Lot 194 - Ballard Road  
1931 Ballard Road  
Fuquay-Varina, NC 27526

# The Selma - LH

29-Apr-2025 - Redlines - DD

5.22.25 Design upgrades - CW

FIRST FLOOR PLAN 'ENGLISH COUNTRY'  
SCALE: 1/8"=1'-0" ON 11x17, 1/4"=1'-0" ON 22x34

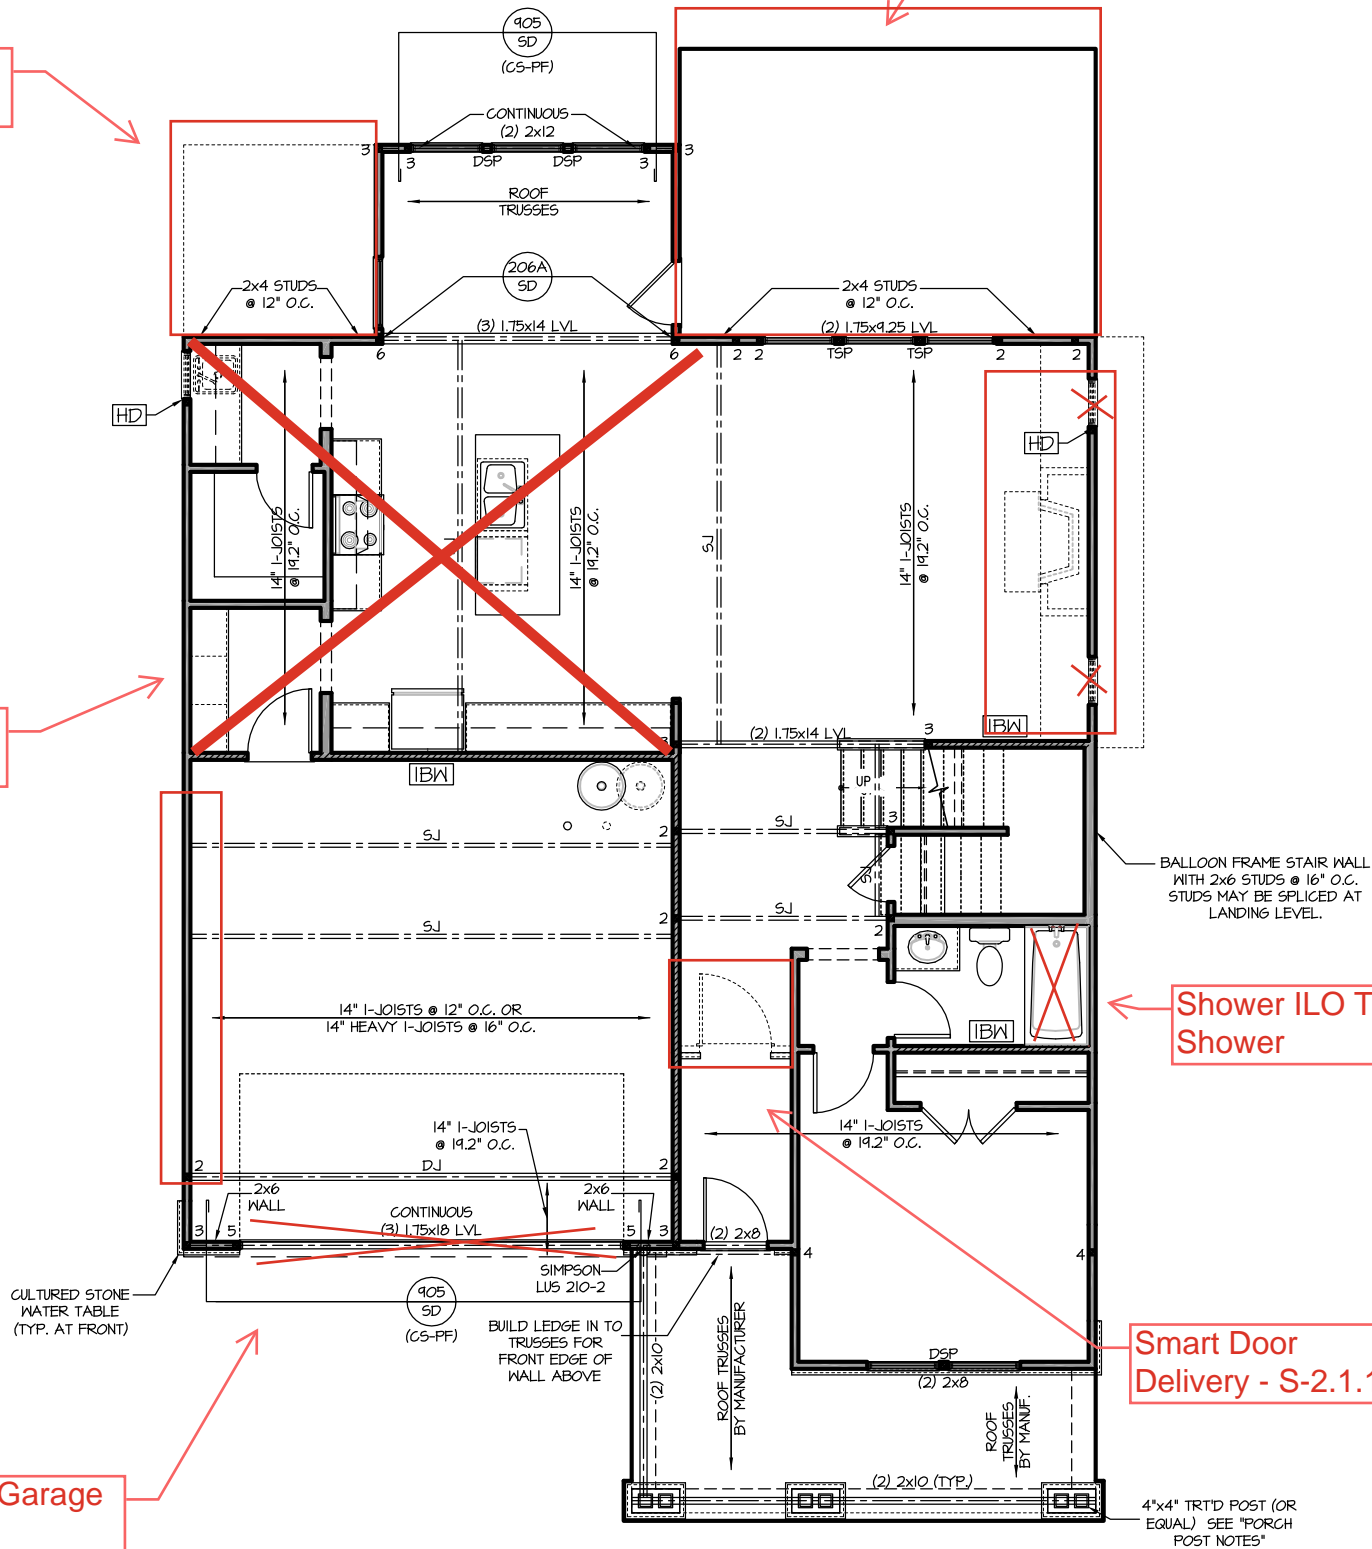
Pocket Office -  
S-2.1.1

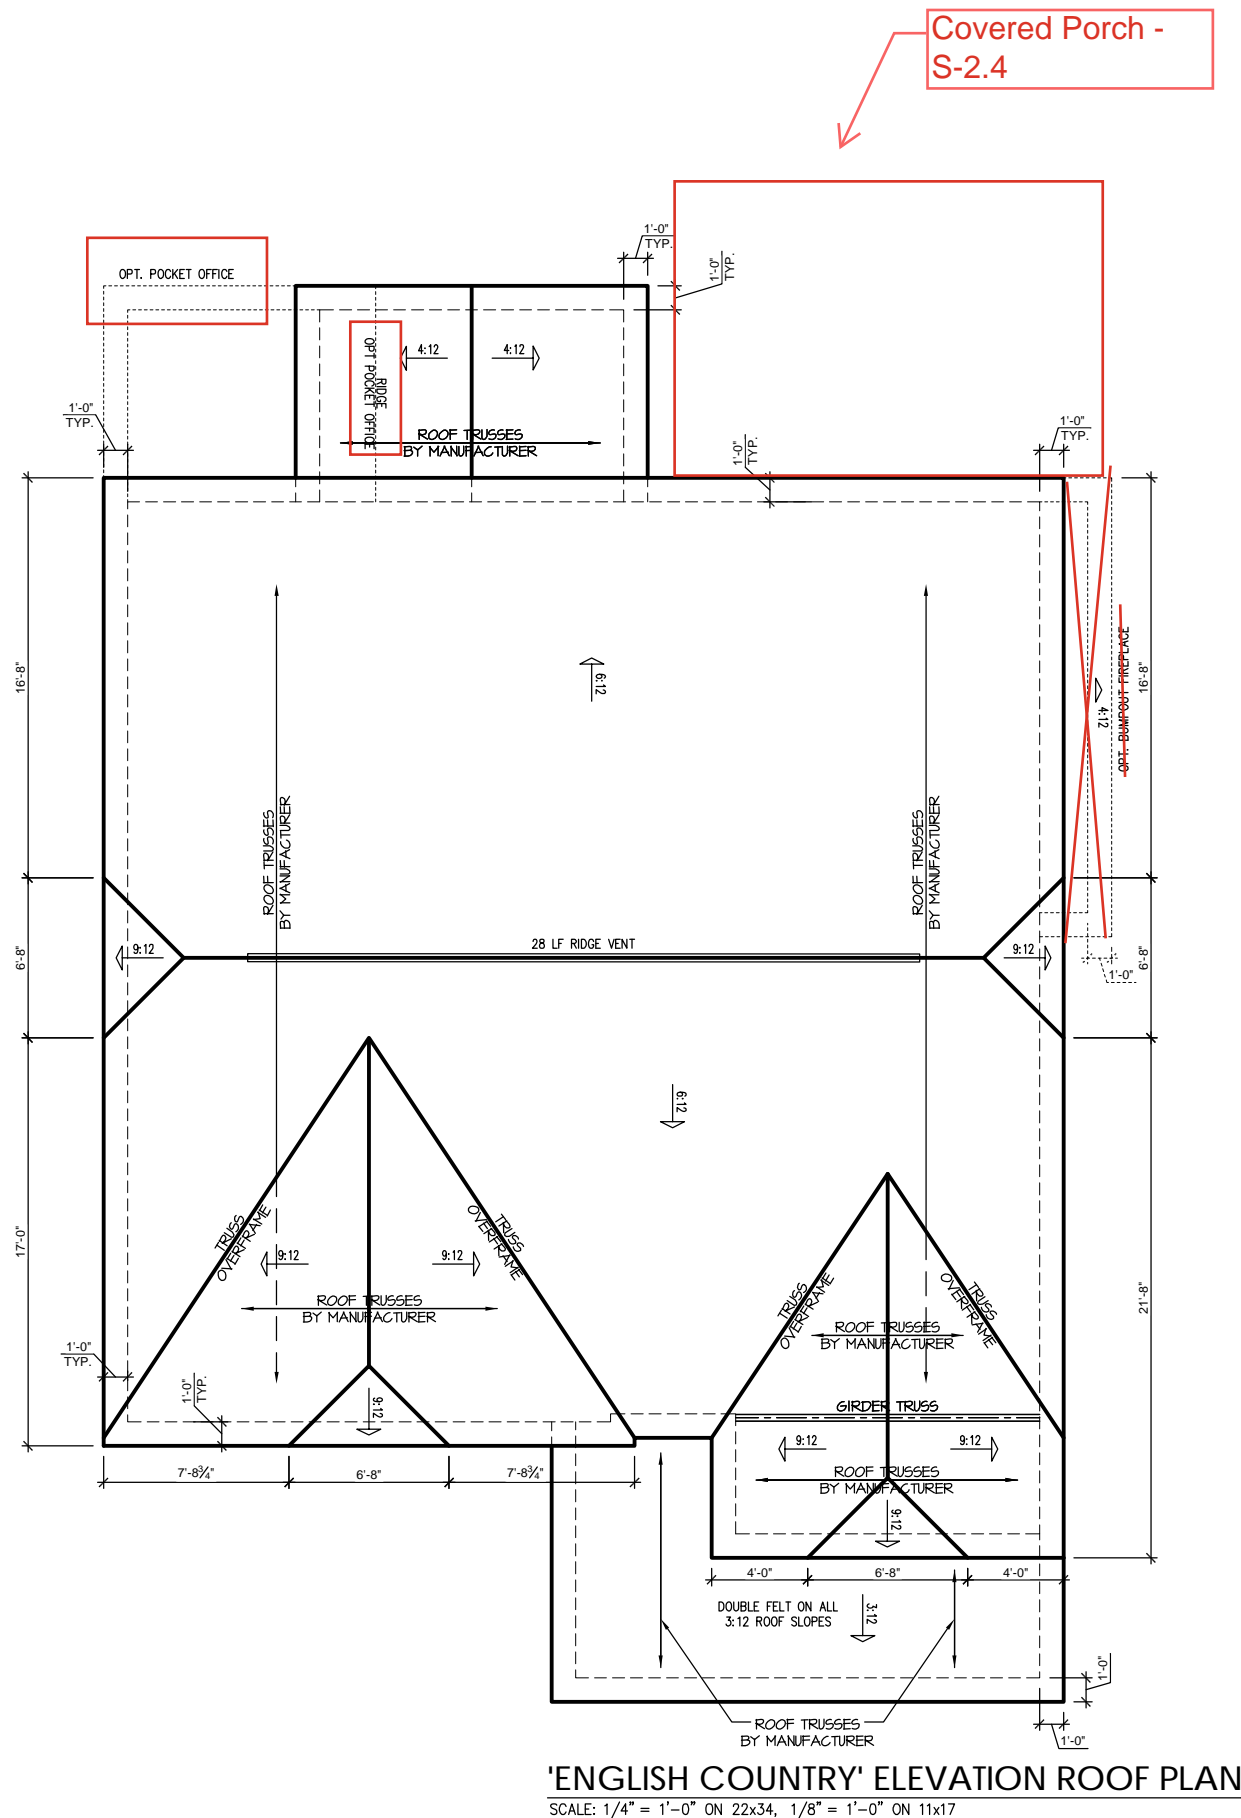
Windows Move  
due to covered  
porch

Pocket Door

Laundry Tub
